REQUESTOR NAME: Clean Energy Association of B.C. (CEBC)

INFORMATION REQUEST ROUND NO: 2

APPLICATION NAME: **Dawson Creek/Chetwynd Area Transmission Project (DCAT)**

The chart below, taken from page 84 of 100 shows the range of gas production forecasts for the Montney region.

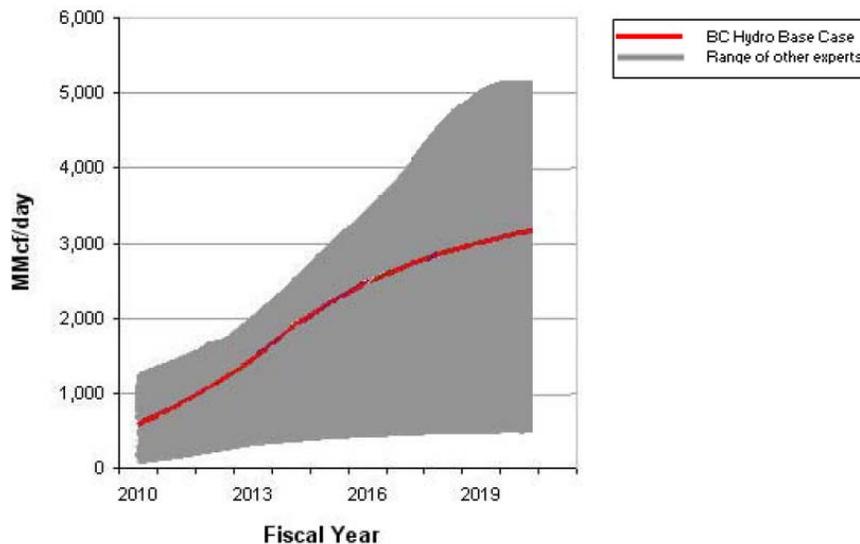
- 3.1 Which of the 5 sub-regions are represented in the forecast shown in the above chart? Does it include all of Dawson Creek, Groundbirch, Chetwynd, GMS, and Fort St. John, or only some of them? What portion of the total regional production is included in the forecast?

- 3.2 Please provide the chart data in table form.
- 3.3 Since we are now 2 ½ years into this forecast period, please provide the actual production rates for F2010, F2011, and the first half of F2012.

- 3.4 Since we are now 2 ½ years into this forecast period, does BC Hydro now have a more up-to-date forecast for the future? Please provide the latest BC Hydro forecast and an updated range of forecasts as depicted in the chart.

- 3.5 What is the total amount of work energy that the gas industry will require to drill, fracture, transport and process the amount of gas production shown in BC Hydro’s “Base Case”? Please give the response in total MWh per year, and also MWh per MMcf. Please include this in the table provided for IR 3.1.

- 3.6 Please also include in the table what portion of the total work energy (in MWh) BC Hydro is forecasting to provide in each year of the forecast period?
